SERVICE BULLETIN

NO. 840A

Date: November 7, 2013

FUEL SELECTOR VALVE COVER REPLACEMENT

Figure 1

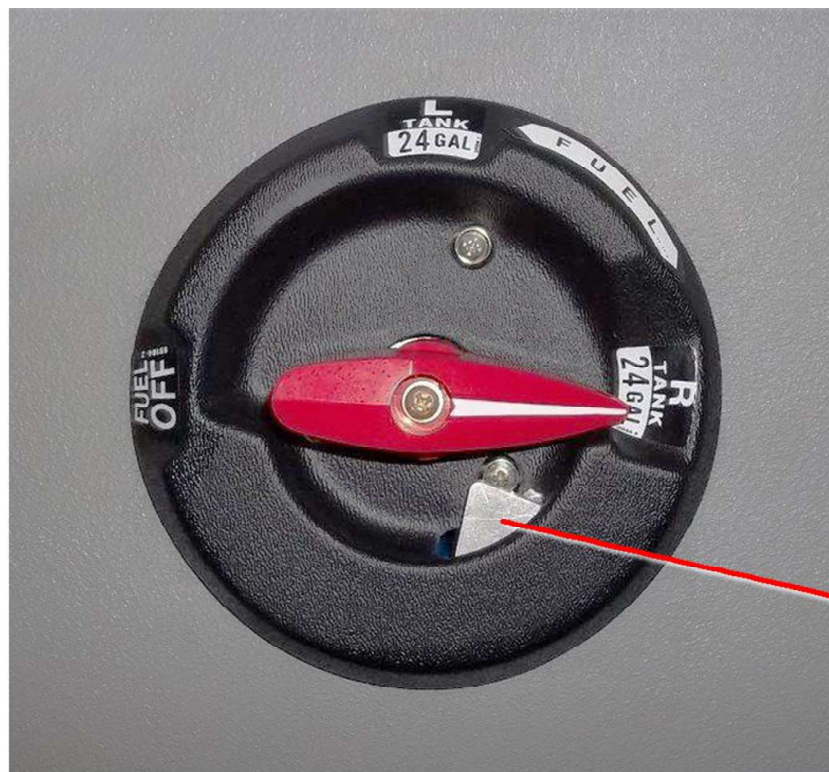
To announce the availability of a new fuel selector valve cover assembly and mating handle, which reduces the possibility of pilot mismanagement of the fuel system through inadvertent selection to the "OFF" position, resulting in power interruption or stoppage.

SPRING LOADED
METAL STOP, PROTRUDING
THROUGH AN OPENING
IN THE COVER

Kits 760-545 and 760-546, shown properly installed.

NOTE: Figure 1 shows proper installation of Piper Part Numbers 760-545 and 760-546. P/N 760-545 is similar to 760-546, except 760-545 includes additional parts and instructions to accommodate an adjacent cabin air vent (cabin air vent not shown in Figure 1).

All instructions necessary to accomplish this modification are contained in Piper Kit No. 760-545, Fuel Selector Valve Cover Replacement.

All instructions necessary to accomplish this modification are contained in Piper Kit No. 760-546, Fuel Selector Valve Cover Replacement.
